**MONTGOMERY COUNTY HISTORIC PRESERVATION COMMISSION**  
**STAFF REPORT**

<b>Address:</b>	5810 Connecticut Avenue, Chevy Chase	<b>Meeting Date:</b>	10/26/2022
<b>Resource:</b>	Outstanding Resource Chevy Chase Village Historic District	<b>Report Date:</b>	10/19/2022
<b>Applicant:</b>	Tracey D'Angelo	<b>Public Notice:</b>	10/12/2022
<b>Review:</b>	Historic Area Work Permit	<b>Tax Credit:</b>	n/a
<b>Case Number:</b>	1001472	<b>Staff:</b>	Rebecca Ballo
<b>Proposal:</b>	Fence installation, removal of existing columns, and construction of new columns.

Email Correspondence with Staff and Applicant for Supporting Documentation  
5810 Connecticut Avenue; HAWP#1001472

WEST PROPERTY LINE FENCE ELEVATION

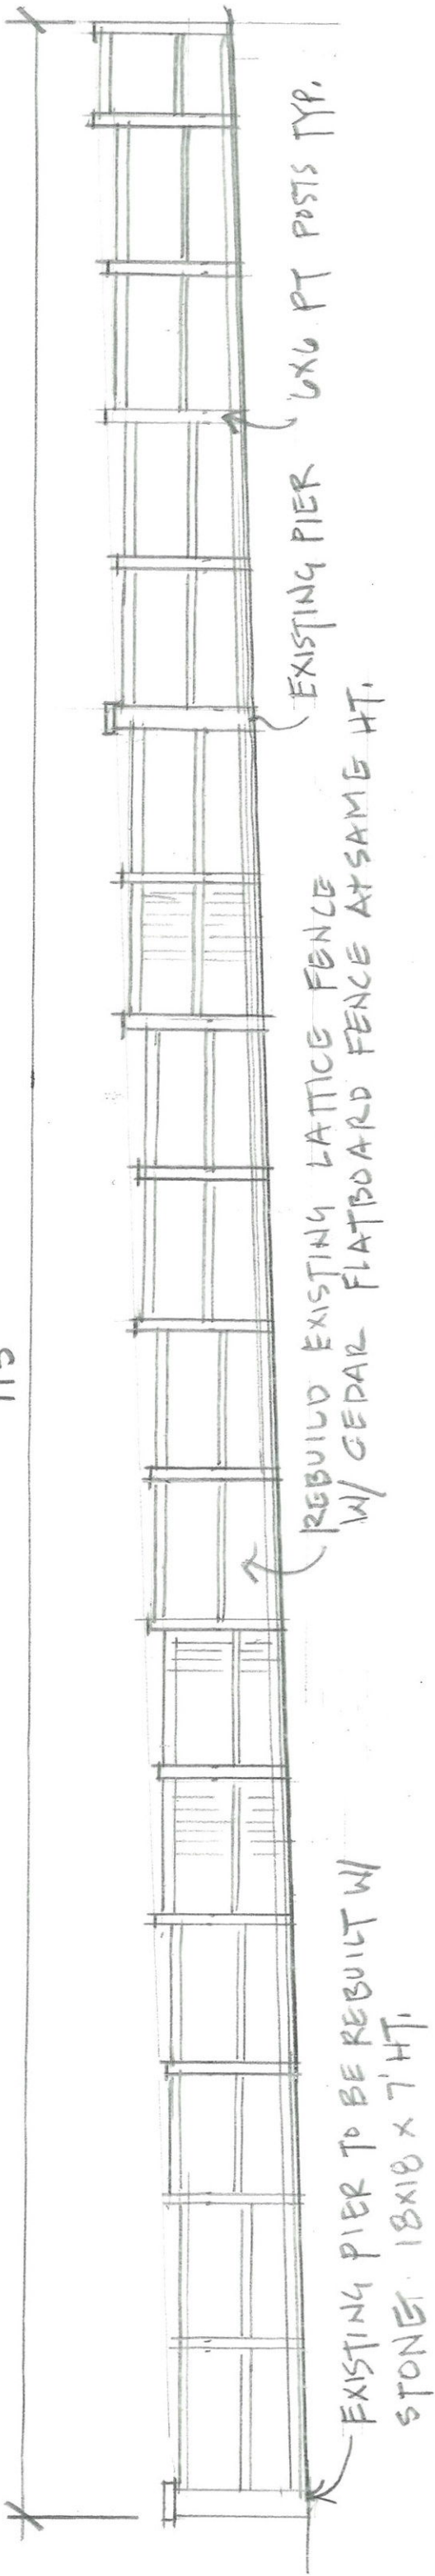
The applicant is first proposing to replace the existing 7’ wood lattice privacy fencing with new 7’ wood board privacy fencing. The fence will be painted per the submitted documentation. There is a letter of support from the adjacent owners at 4 West Irving Street for this alteration. Under the ‘moderate scrutiny’ standard, this change in the design will not detract from the integrity of the resource in question. There will be less transparency when looking at the back of the property from 4 West Irving Street, but this will not be detrimental to have a more obstructed view when looking at the rear of the property from West Irving Street.

1. Confirmation that the proposed fence and column heights meet the zoning and fencing requirements for Chevy Chase Village.
2. Images of the proposed flat board privacy fencing. The image that you show in page 7 is an oblique view and the Commission will need to see one head on, or have the drawings show the dimensions between the slats, if any. Typically, privacy fences have no openings between the boards and are completely opaque, but this creates a fence that is less 'open' than what you currently have. Please clarify.

CONNECTICUT AVENUE FENCE ELEVATION

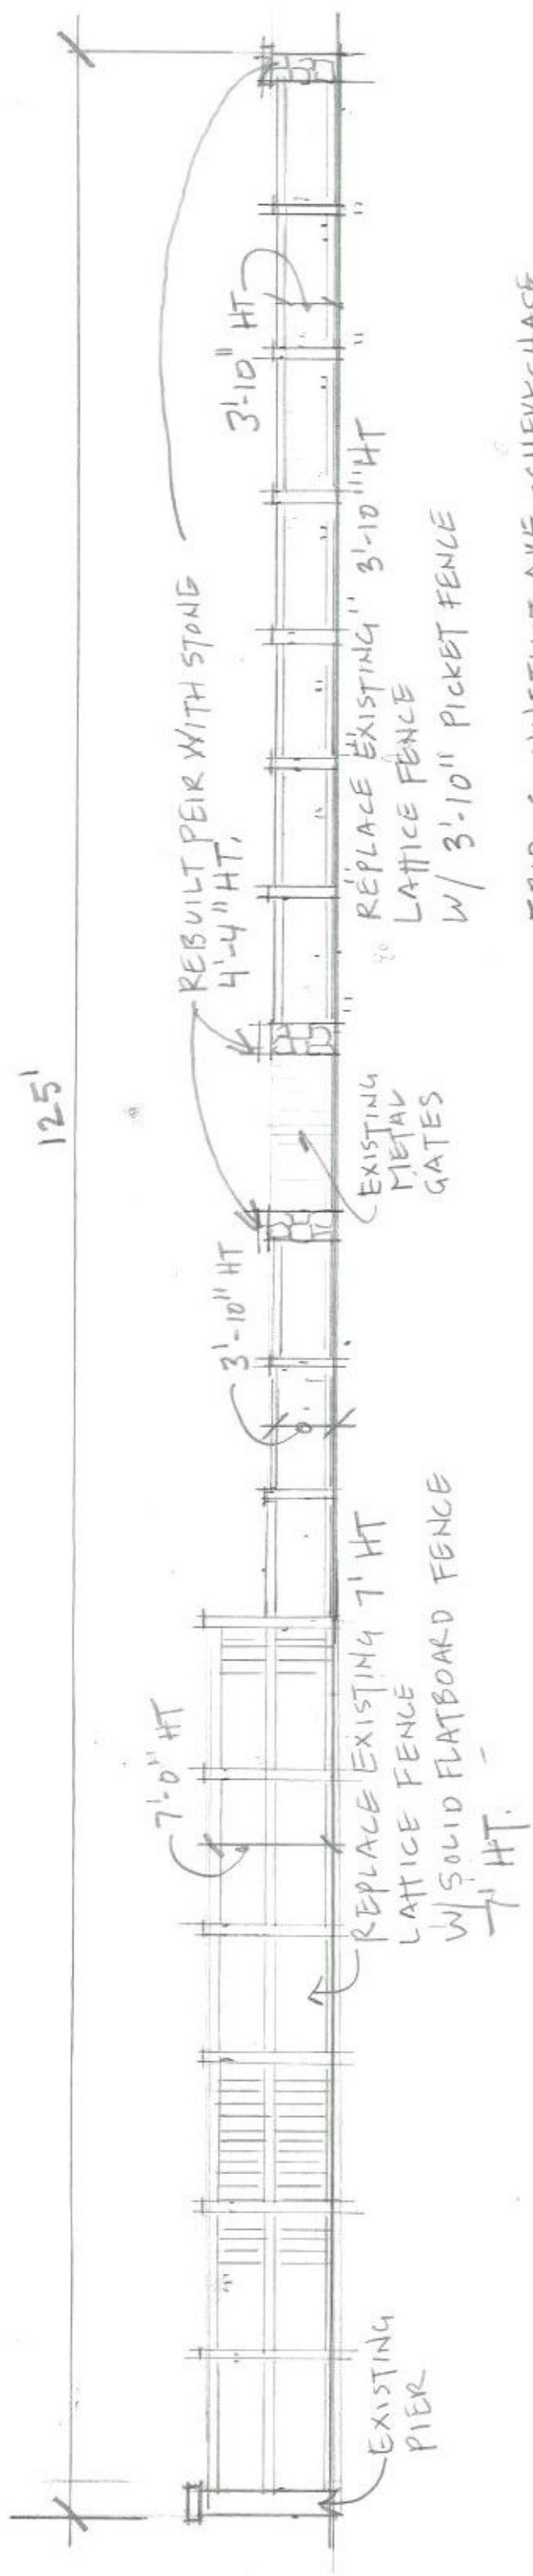
The third alteration is the proposed replacement of the stucco and Styrofoam columns with stacked stone columns. First staff looked at the streetscape along Connecticut Avenue and requested examples from the applicant where this material has been used in the district. The applicant submitted several examples that are in the attached application. Directly across the street from the subject property is the Newlands Corby Mansion at 9 Chevy Chase Circle. That property contains a stacked stone wall and tall entrance columns along its entire frontage along Connecticut Avenue. The property immediately to the south at 5804 Connecticut Avenue has an open metal fence with 7’ tall brick piers.

4. Detailed explanation about how a fieldstone stacked column is architecturally appropriate for the Mediterranean revival house. If there are other examples where these columns have been used at similar sites within the District, that would bolster the narrative. These columns are more typically seen at Federal or similar period homes out in the Ag Reserve or nearby farming communities when the stones that were turned up by plowing were stacked for stone walls and other site elements. Their recent upsurge in popularity has much to do with recent (2010s-2020s) farmhouse revival trends. Please provide additional information or context about how this style is compatible with the house.

In response to your question about how the proposed stone columns are appropriate for our home, I would urge you to consider the historically widespread presence of stone columns and retaining walls throughout the Chevy Chase Historic District and surrounding area. We feel that they are an important theme in the fabric of our neighborhood and will convey a sense of harmony with nearby historic properties. In particular, inspiration for the columns that we propose comes from the house next door to ours as well as a number of other homes in our community (of varying styles). While it is nearly impossible to recreate these old columns exactly today, given the difficulty of obtaining raw materials, etc., we hope our columns will echo the venerable columns still scattered around the Chevy Chase Historic District. I have attached some photos below and will add them to the dropbox for our application.

Regarding the appropriateness of these columns on a Mediterranean revival house, I would again dispute the idea that our house is truly of that designation. Although we do have a red tile roof and some arched windows, the original brick was the brownish brick that you see on many DC turn of the (20th) century houses and the layout and original interiors are much more conventionally colonial(ish). As you drive around the city, there are several house that have similar features to ours (same brick, roof) and stone columns or retaining walls similar to the ones pictured below. I think the mix of styles is very consistent and appropriate to the region's propensity to embrace "blended" architectural styles in single properties.
